Supplementary Report for the Planning and Development Board

PAP/2023/0071

Land 800 metres south of Park House Farm, Meriden Road, Fillongley

Review of Drainage Strategy, Flood Risk Assessment and LLFA Consultation Response for Fillongley Flood Group

Image from Soilscape website showing soil infiltration slightly impeded, and quite fertile soil.

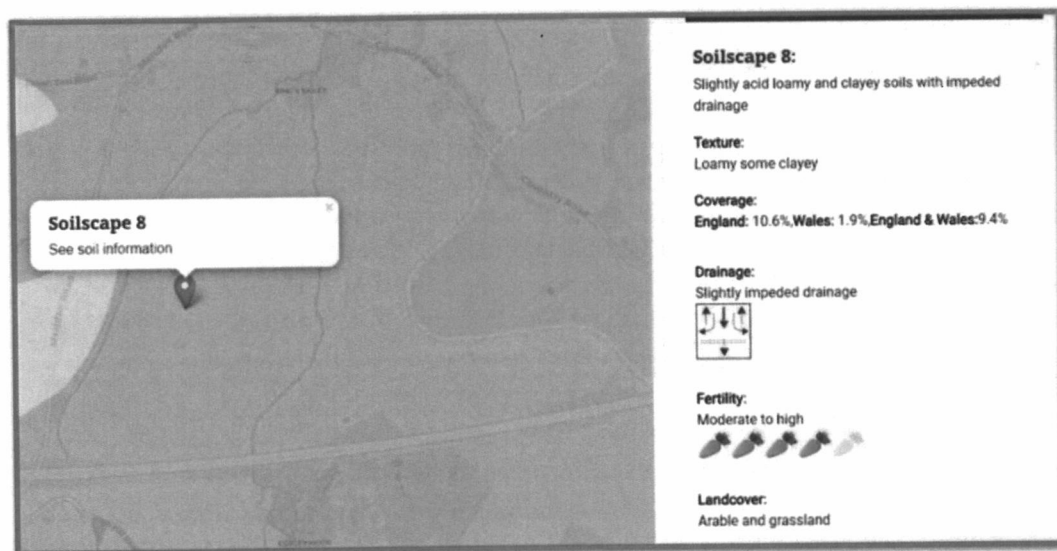
- 12 2.8 Geology – this section does not consider the soil characteristics – see Soilscales viewer page below – showing that the soil has slightly impeded permeability (consistent with the presence of watercourses).
